# City of Corpus Christi

### Planning Commission

Wednesday, January 11, 2023

**TECHNICAL REVIEW PLAT REQUIREMENTS  
REGULAR PLANNING COMMISSION MEETING  
January 11, 2023**

PRELIMINARY PLAT OF  
GRAHAM ESTATES

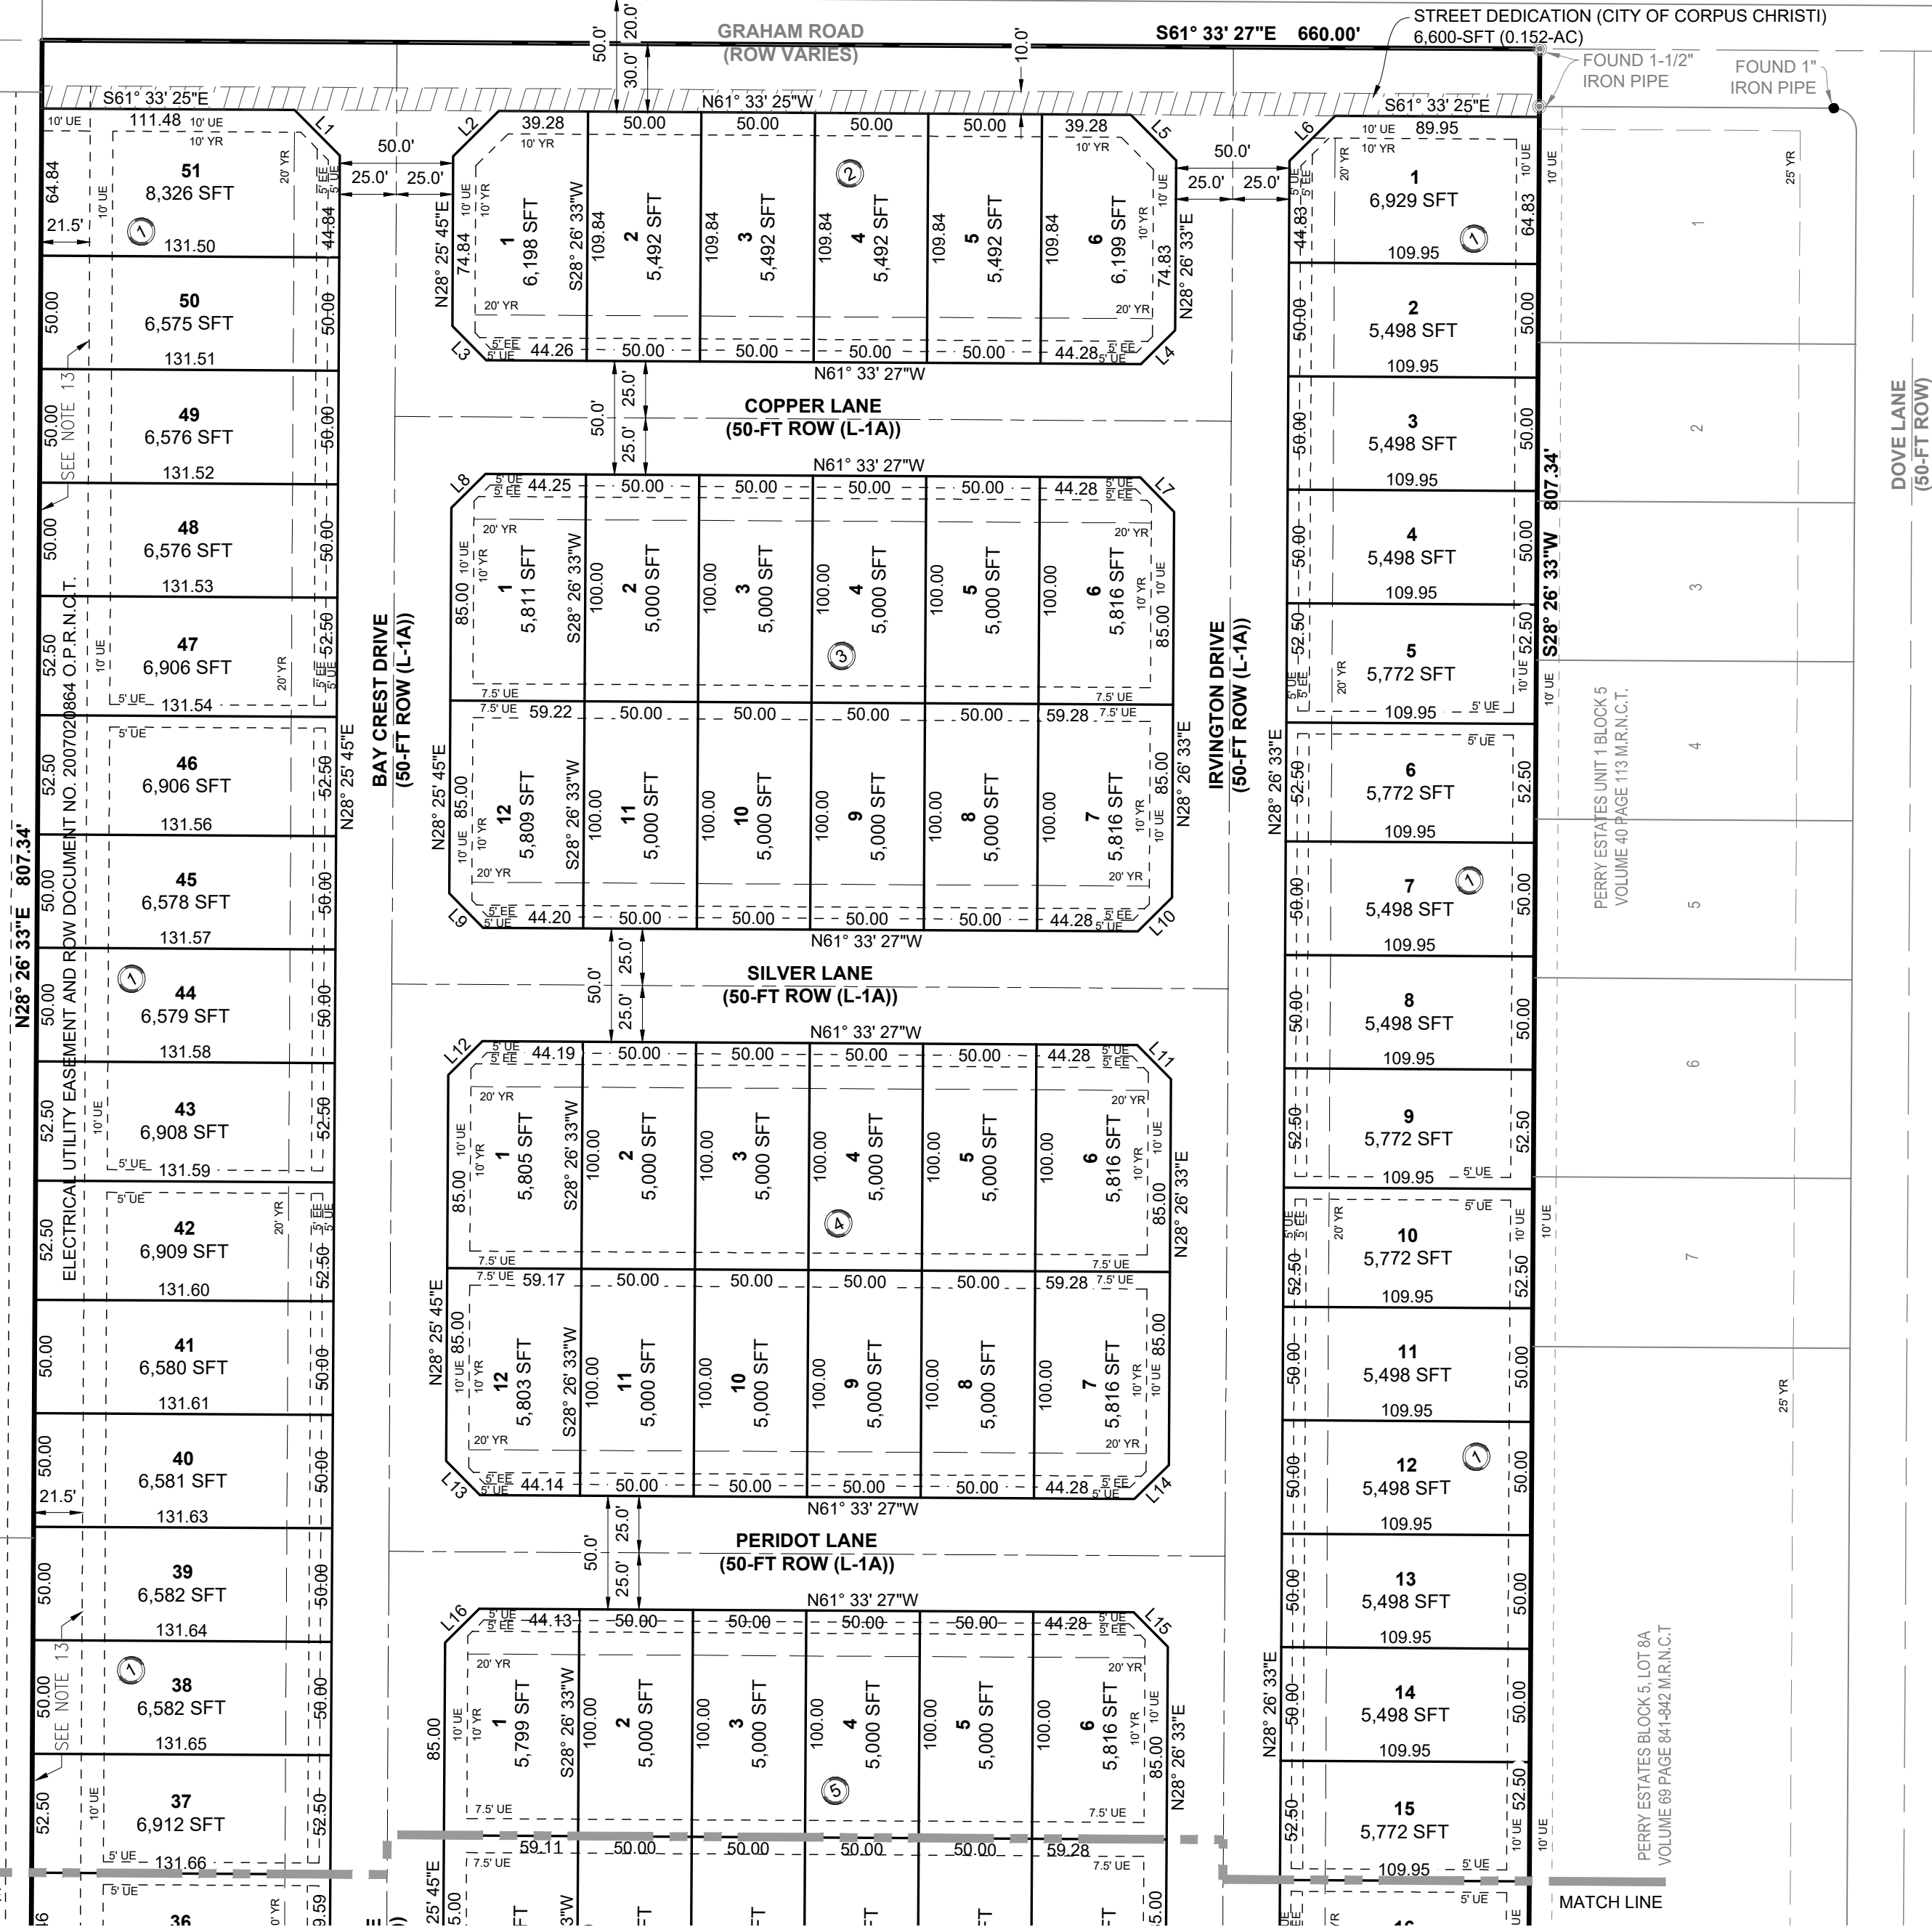
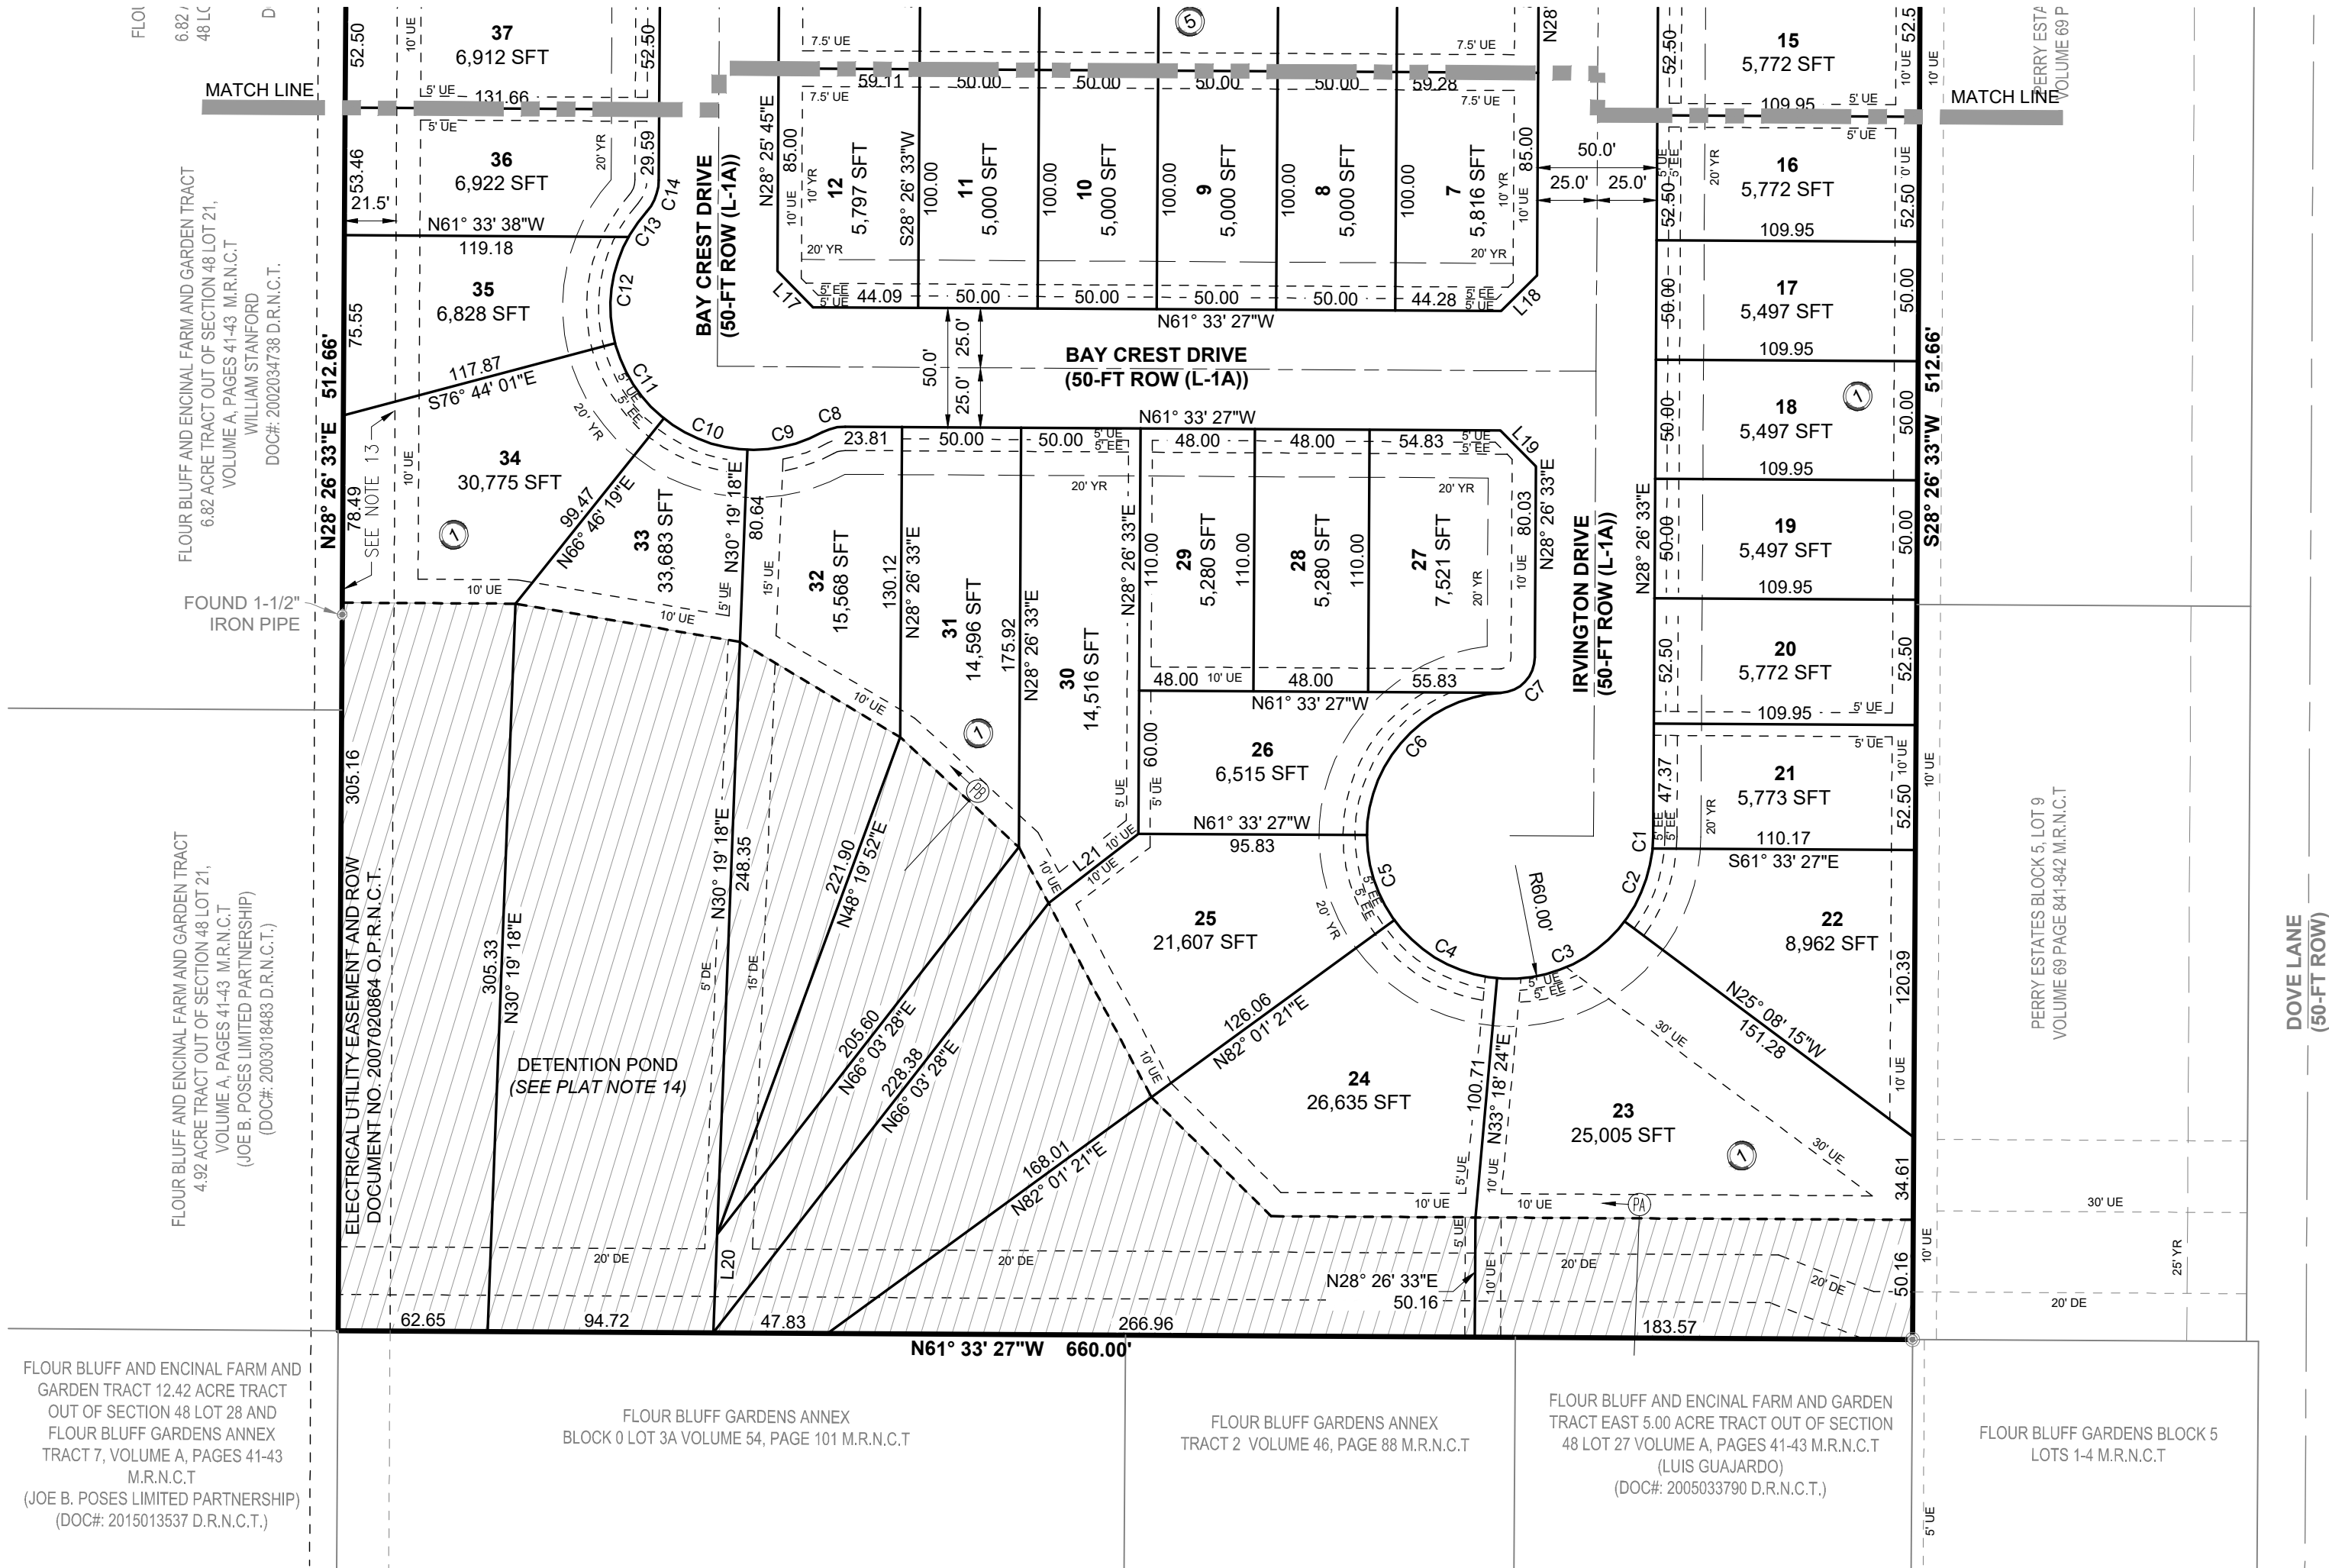
GIS						
No.	Sheet	Comment	Applicant Response	Staff Resolution	Applicant Response	Staff Resolution
1	Plat	Plat closes to acceptable engineering standards. (TSPS Manual of Practice Appendix A, Condition 3; Suburban Traverse Error of Closure)	Okay			
2	Plat	Location map does not add context to general location of platted area. Pls revise.	Revised	Addressed.

LAND DEVELOPMENT						
No.	Sheet	Comment	Applicant Response	Staff Resolution	Applicant Response	Staff Resolution
1	Plat	For the street dedication on Graham Rd, indicate total acreage and the depth.	Added	Addressed.		
2	Plat	Add note to item 1 that street dedication is included.	Added	Addressed.		
3	Plat	Match font size under item 2.	Adjusted	Addressed.		
4	Plat	Add a "NOTES" title to the plat notes.	Added	Addressed.		
5	Plat	Remove s from yard requirement note.	Removed	Addressed.		
6	Plat	Identify private access, improvements, and easements if there are any on plat.	Indicated in notes	Addressed.		
7	Plat	For private improvements, provision shall be made for the establishment of a home owners association or other entity in accordance with the requirements of Subsection 8.1.8, Home Owners Associations, for the proper and continuous operation, maintenance and supervision of such improvements.(UDC 8.1.7)	Will be provided	Addressed.

8	Plat	The final plat and HOA document shall make reference to recorded restrictive covenants which shall provide for the perpetual maintenance of private streets by a home owners association to the same standards as connecting public streets for the safe use of persons using the streets and state that the City has no obligation or intention to ever accept such streets as public right-of-way. Such covenants, as approved by the City, shall not be altered without City approval. The restrictive covenants shall be recorded prior to issuance of the first building permit for the subdivision. (UDC 8.2.1.J.8)	Will be provided	<b>Addressed.</b>		
9	Plat	The final plat and HOA document shall contain language whereby the home owners association agrees to release, indemnify, defend and hold harmless any governmental entity for damages to a) Private streets reasonably used by government vehicles. b) Injuries or damages to other persons, properties or vehicles claimed as a result of street design or construction (UDC 8.2.1.J.14).	Will be provided	<b>Addressed.</b>

10	Plat	Provide the following note if applicable: <i>“This subdivision contains private improvements, including but not limited to, streets, facilities and easements that have not been dedicated to the public or accepted by the City of Corpus Christi or any other local government agency as public rights-of-way. The City of Corpus Christi has no obligation, nor does any other local government agency have any obligation, to maintain, repair, install or construct private improvements within the subdivision and shall agree to indemnify, agency from all claims, damages and losses arising out of the construction, reconstruction, maintenance and operation of the private improvements”</i>	Added	<b>Addressed.</b>		
11	Plat	Submit a legal instrument for a Home Owner's Association for approval by the city attorney prior to any plat recordation. (UDC 8.1.8)	Will be provided	<b>Addressed.</b>		
12	Plat	Show and label the proposed phasing and scheduling of development (UDC Section 3.7 Master Preliminary Plat).	Added	<b>Addressed.</b>

13	Plat	Show and label monuments on plat map. Provide a found monument note as well.	Indicated	<b>Not Addressed.</b>	Provide and identified	<b>Addressed.</b>
14	Plat	Streets names are not legible on location map.	Revised	<b>Addressed.</b>		
15	Plat	Verify square footages for lots 23-25, and 30-34.	Verified	<b>Addressed.</b>		
16	Plat	There are random D letters at some of the lots' common boundary lines.	Removed	<b>Addressed.</b>		
17	<del>Plat</del>	<del>Provide the name of subdivision and description on each plat sheets.</del>	<del>Provided</del>	<b>Comment rescinded.</b>	Okay	<b>Addressed.</b>
18	Plat	Show all utility easements and lines on Perry Estates Block 5, lots 8A and 9.	Indicated	<b>Addressed.</b>		
19	Plat	Show outline of pond on adjacent properties.		<b>Addressed.</b>		
20	Plat	Provide width of the Electrical Utility Easement at the western property boundary.	Provided	<b>Addressed.</b>

21	Plat	Three of the lots at the southern boundary line of the plat are lots of record. Label them as such.	Adjusted	<b>Not addressed.</b>		<b>Addressed.</b>
22	Plat	Remove the M.R.N.C.T. abbreviations at the end of the lots' names.	Part of legal, remains	<b>Addressed.</b>		
23	Plat	Verity that the description for the lot owned by Luis Guajardo is correct.	Corrected	<b>Addressed.</b>		
24	Plat	Is note 13 referring to current property owner or future property owner of lots? Clarify.	Texas Property Code - PROP § 28.001. Definitions - “Owner” means a person or entity, other than a governmental entity, with an interest in real property that is improved, for whom an improvement is made, and who ordered the improvement to be made.	<b>Addressed.</b>		
25	Plat	Development Services fees are not assessed on preliminary plats.	Okay	<b>Addressed.</b>

DEVELOPMENT SERVICES ENGINEERING						
No.	Sheet	Comment	Applicant Response	Staff Resolution	Applicant Response	Staff Resolution
1	Plat	Development on this site shall manage storm water drainage caused by the development of the property, drainage directed to the property by ultimate development, and drainage naturally flowing onto and through the property per UDC 8.2.8.B.2.	Okay	Addressed		
2	Plat	Provide definitions for Items A - G on the Street Cross Section	Added	Addressed		
3	Plat	Provide a 5-foot Public Utility Easement and the 5-foot Electrical Easement on lot fronts. Backlot Easements may be reduced to 7.5 feet on adjacent lots. Or provide a rational for the proposed easement layout.	Adjusted	Addressed		
4	Public Improvement Plans	Public Improvements Plans are required at Final Plat; submit a pdf copy of proposed public improvements along with a title sheet to PublicImprovements@cctexas.com for review and approval; this item is required prior to Final Plat Recordation. UDC 8.1.3.A	Provided	Not addressed. No Public Improvements were provided on this submittal. You may address at final plat	Will be provided after final plat	To be addressed by Public Improvements.

5	Utilities	Design information to be provided with Final Plat / Public Improvement plans. City may request additional information, as deemed necessary for future reviews and approvals.	Noted	Addressed		
6	SWQMP	Provide the following missing information: Legal Description of property, plat name, disturbed acreage, current on -site drainage, proposed drainage after development.	Provided	Addressed

7	SWQMP	Confirm that rainfall intensity and run-off calculation coefficients are consistent with the Current Infrastructure Design Manual.	Adjusted	Not addressed. Missing calculations on SWQMP 1 and SWQMP 2 is blank with only the engineer seal	Information provided	Addressed.
8	SWQMP	Pre-, and post-development runoff is shown to be the same. Confirm this is correct or provide updated calculations.	Adjusted	Not addressed. Missing calculations. The SWQMP 1 is missing the info	Information provided	Addressed.
9	SWQMP	Sheet 3 of 3 of the plat notes the existing pond as a Detention Pond. Provide detention calculations.	Added	Not addressed. Missing calculations	Information provided	Addressed.
10	SWQMP	Provide estimated flows at each outfall with Final Plat/ Public Improvement Plans.	Provided	Not addressed. The estimated 5yr event flows were provided but since the pre and post calculation are missing we don't have the numbers to make sure they add up to the 5 yr event	Information provided	Addressed.

12	SWQMP	Excess runoff from the pond is shown draining to the east from the pond through a 20 foot wide drainage easement - provide a cross section of the proposed drainage pond/ditch from the exiting pond.	Provided	Addressed		
13	SWQMP	How is runoff conveyed through the adjacent property to Dove Lane, and how does the runoff get from this point to an exiting or proposed drainage structure? The provided routing map appears to show runoff crossing private property to get to the receiving waters.	The conveyance has been adjusted to continue south down Dove Lane and to Blossom Street and into the stormwater system.	Are you allowed to drain water through this property do you have an easement agreement? Please provide copy. Also The SWQMP 4 indicates you will be draining through a 20' drainage easement. We are unable to find the 20' easement on city maps. Please provide	Plat indicates a easement, plat is submitted for reference	Addressed. This applicant response did not suffice, but staff did research and found recordation of 20' easement on neighboring property's plat which is being sent to GIS to update the map. In the future, provide all related plats and easements to expedite review time, not just the proposed plat.

UTILITIES ENGINEERING						
No.	Sheet	Comment	Applicant Response	Staff Resolution	Applicant Response	Staff Resolution
1	Plat	Water construction is required for platting (UDC 1.2.1.D & 8.2.6; Water Distribution Standards).	Will be provided	Addressed.		
2	Plat	Wastewater construction is required for platting (UDC 1.2.1.D & 8.2.7;Wastewater Collection System Standards).	Will be provided	Addressed.
